Subject: UniStar Nuclear Energy, NRC Docket No. 52-016
Response to Request for Additional Information for the
Calvert Cliffs Nuclear Power Plant, Unit 3,
RAI 357, Pressure-Temperature Limits, Upper-Shelf Energy, and Pressurized
Thermal Shock

UN#12-067

Subject: UniStar Nuclear Energy, NRC Docket No. 52-016
Correction of Final Safety Analysis Report (FSAR) Figure 8.3-1
in Calvert Cliffs Nuclear Power Plant, Unit 3, Combined
License Application (COLA) Revision 8

**Correction of Final Safety Analysis Report (FSAR) Figure 8.3-1,
COLA Revision 8, Calvert Cliffs Nuclear Power Plant, Unit 3**

Figure 8.3-1—{CCNPP Unit 3 Emergency Power Supply System Single Line Drawing}
(Page 2 of 3)

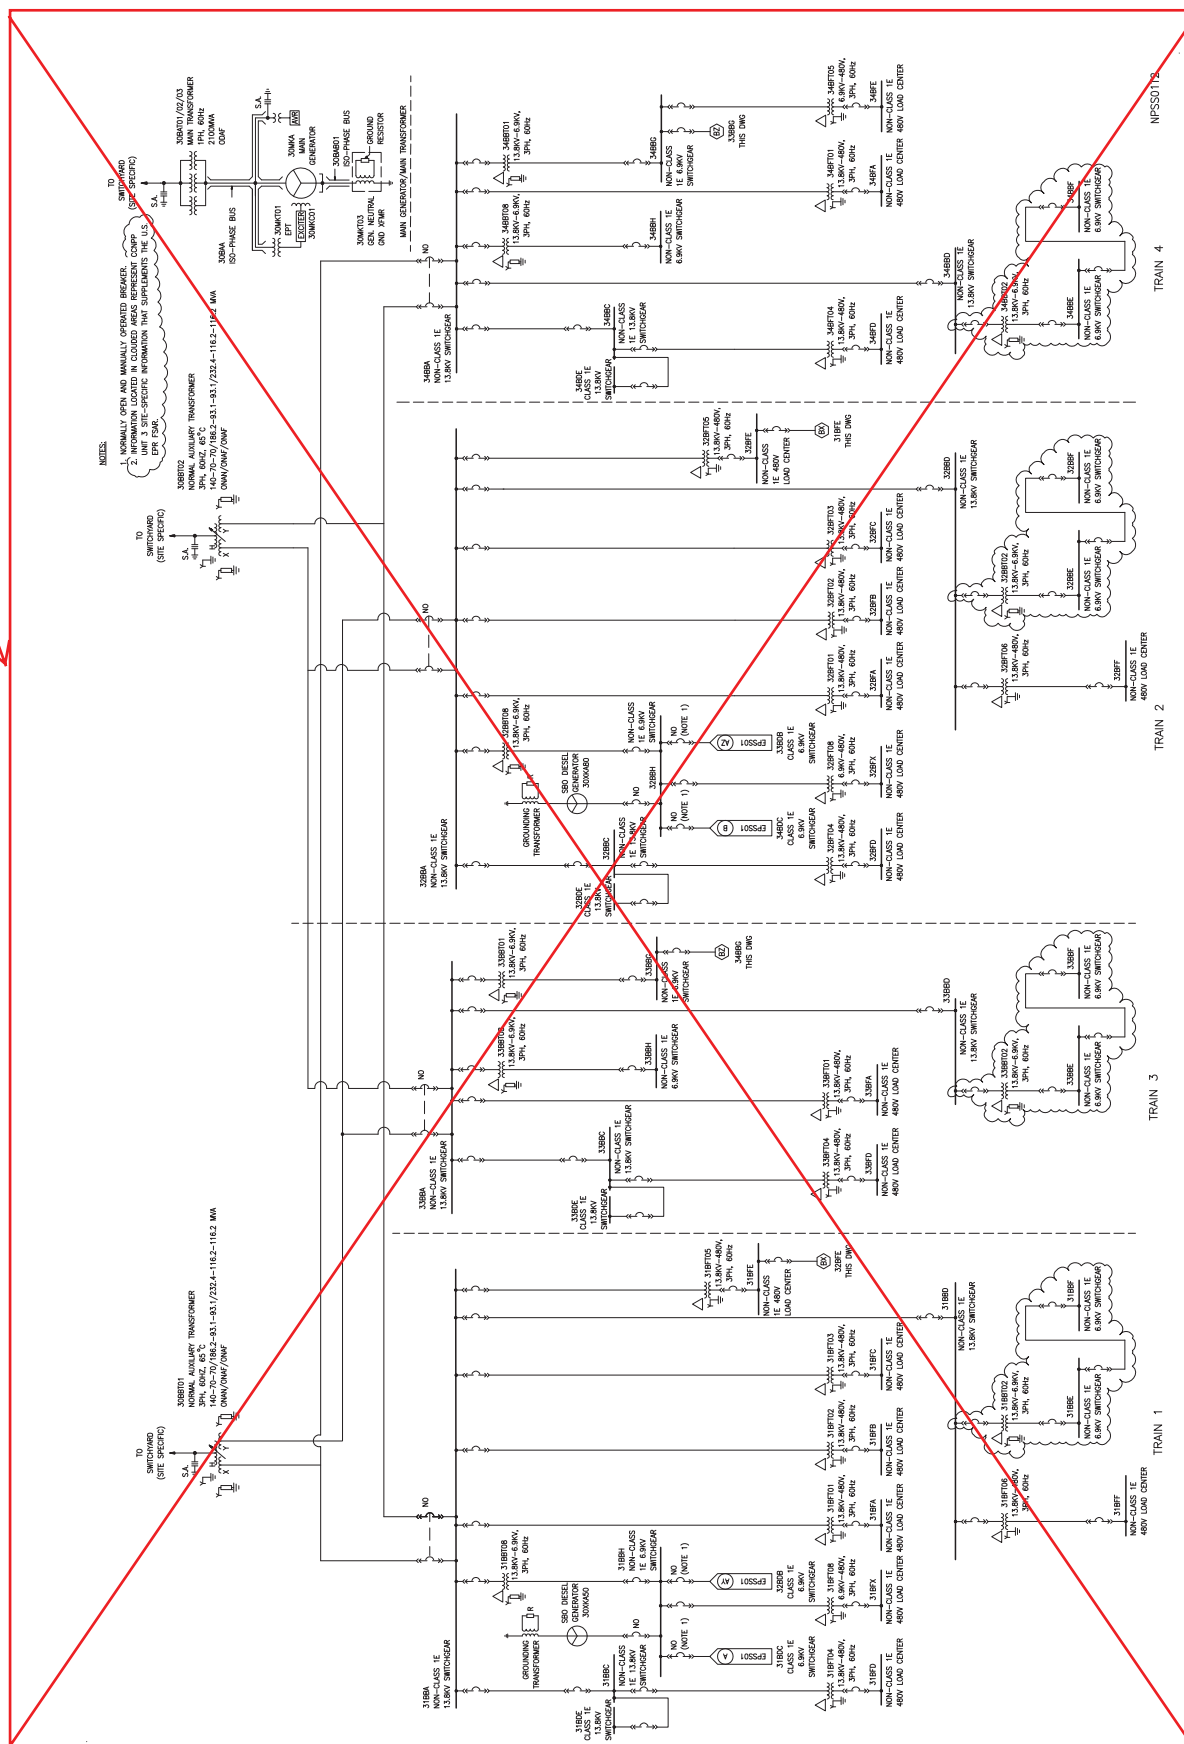
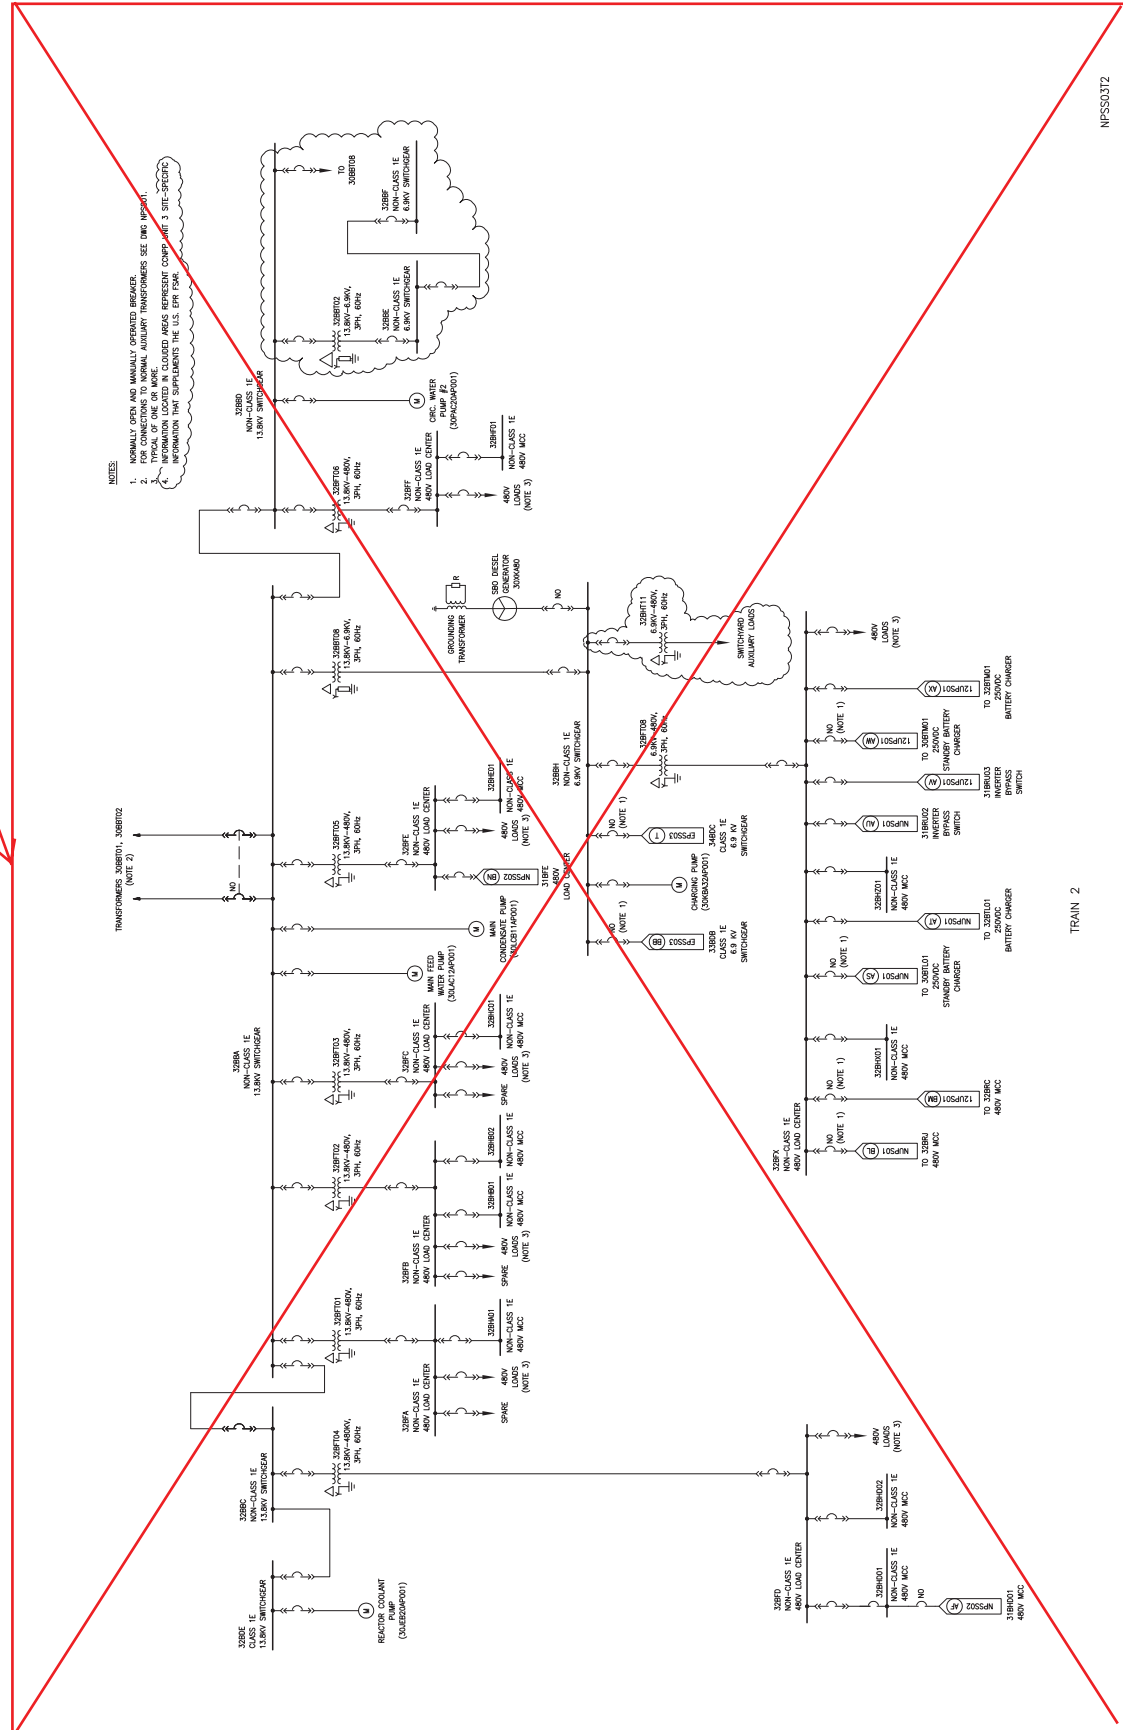
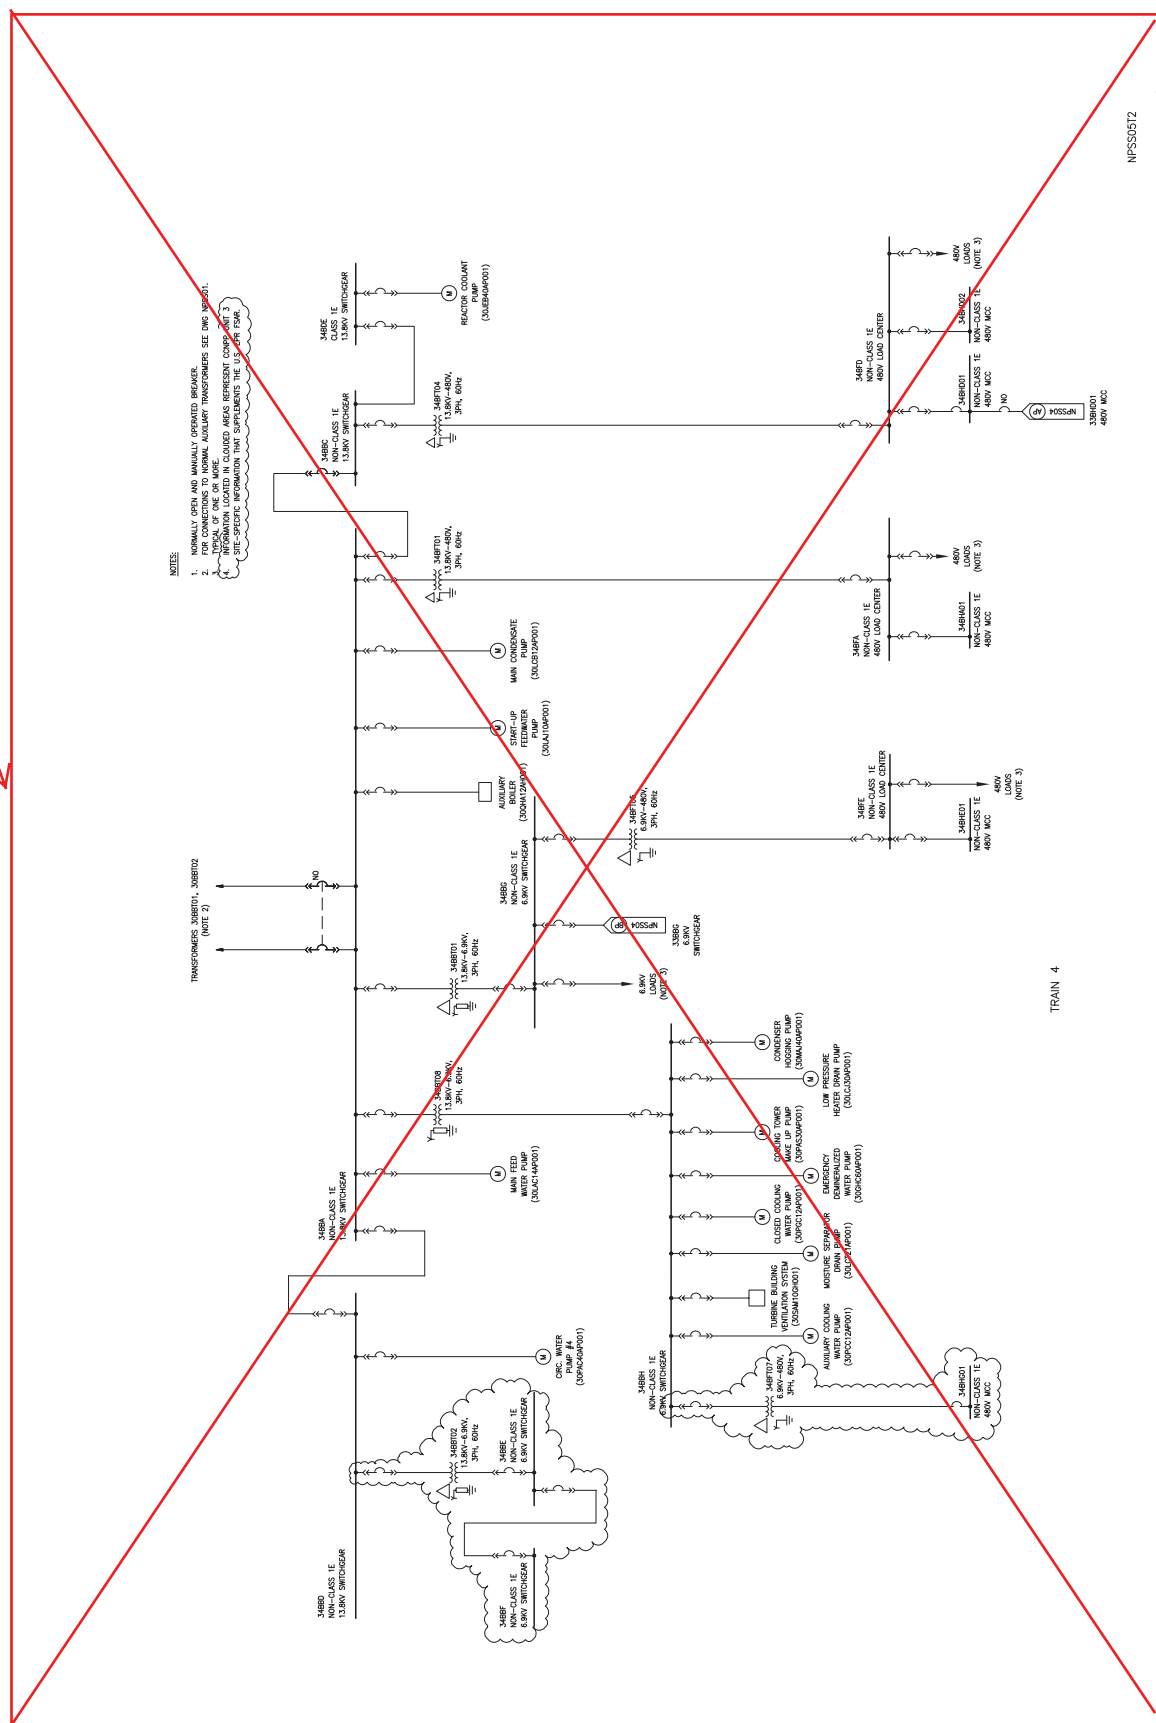
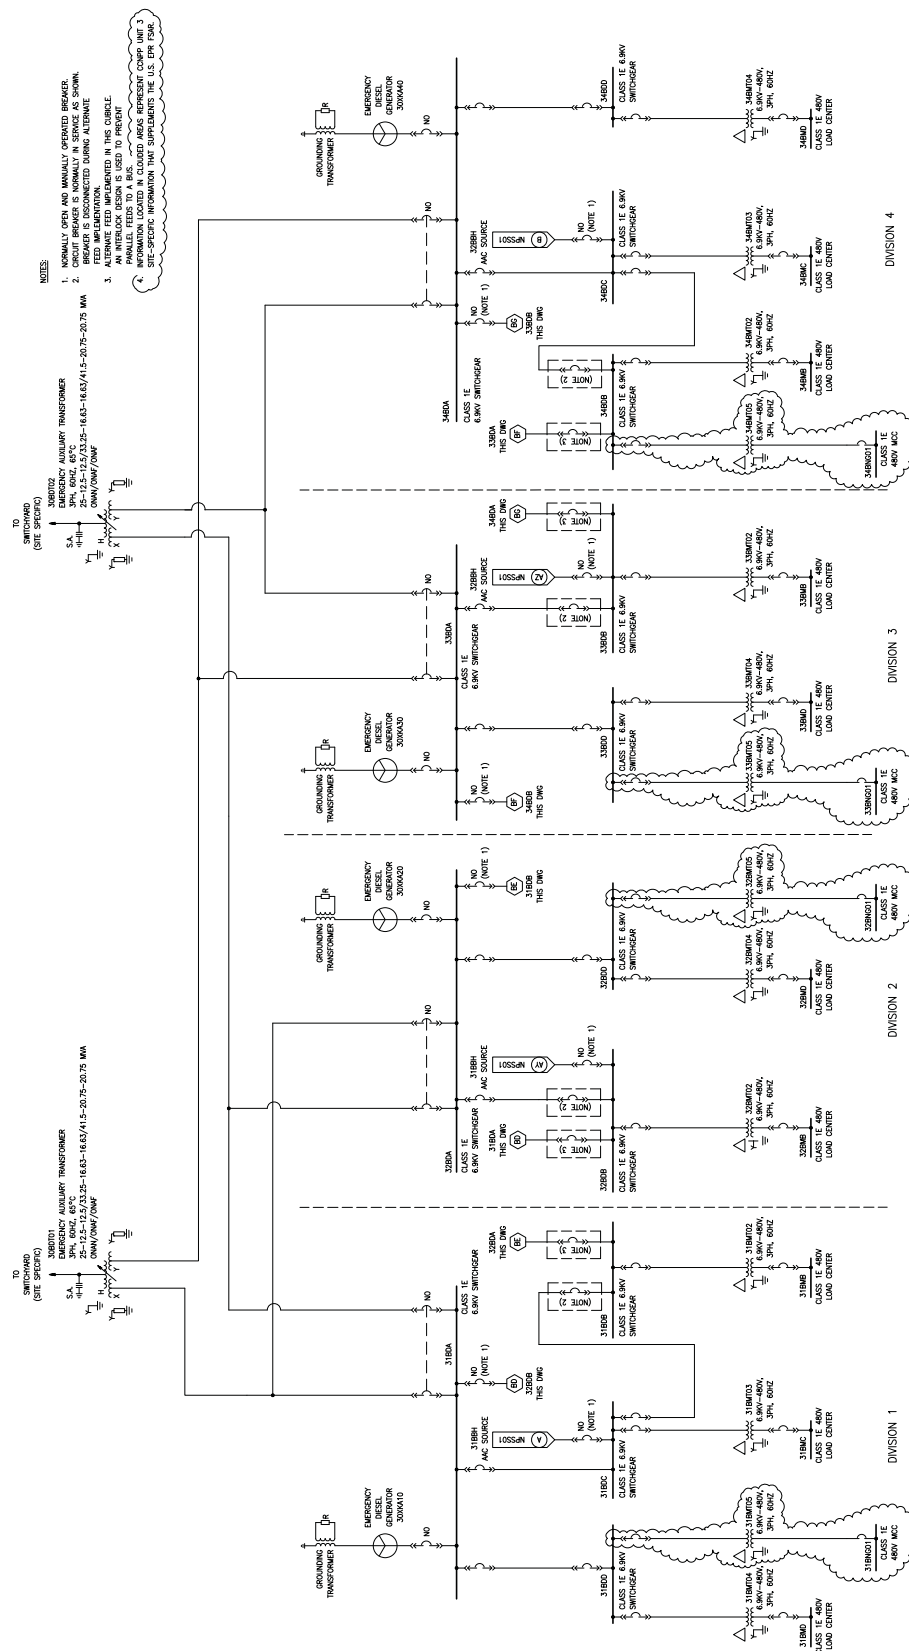
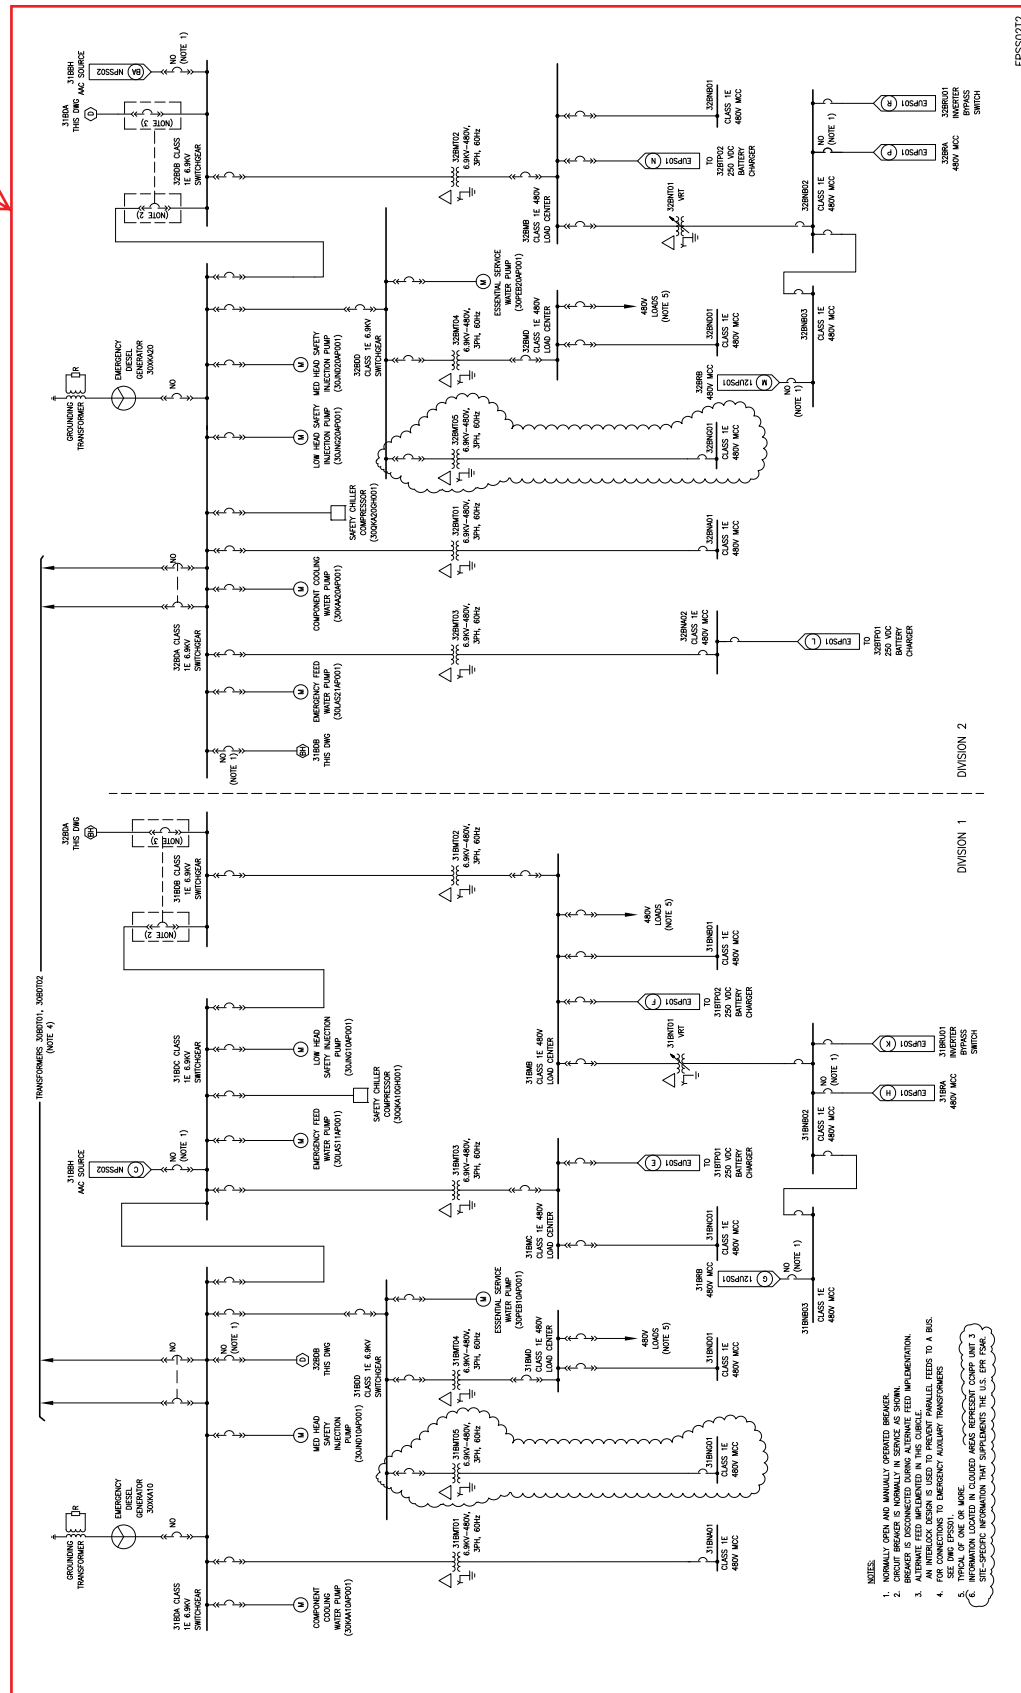
The purpose of this letter is to provide a correction to Final Safety Analysis Report (FSAR) Figure 8.3-1 as presented in Calvert Cliffs Nuclear Power Plant (CCNPP), Unit 3, Combined License Application (COLA) Revision 8 (Reference 2). In a call with the CCNPP NRC Project Manager, UniStar Nuclear Energy (UNE) was questioned why FSAR Figure 8.3-1 was revised in COLA Revision 8. The revised Figure 8.3-1 was incorrect.

Initial investigation into this condition revealed that COLA Revision 8 changes were required to subsequent FSAR Figure 8.3-2 (Pages 1, 3, and 5 of 5). However, in COLA processing, FSAR Figure 8.3-1 (Pages 1 through 3) were also inadvertently replaced with the duplicate FSAR

Figure 8.3-2 pages (Pages 1, 3, and 5 of 5). A condition report regarding the incorrect FSAR Figure 8.3-1 revision in COLA Revision 8 has been entered into the UNE corrective action program for disposition.

FSAR Figure 8.3-1 should not have been revised in COLA Revision 8. FSAR Figure 8.3-1, as shown in COLA Revision 7 (Reference 1), remains correct. The enclosure to this letter provides a markup of the correction which is being made to FSAR Figure 8.3-1 to restore the correct figure. A Licensing Basis Document Change Request has been initiated to incorporate these changes into a future revision of the COLA.
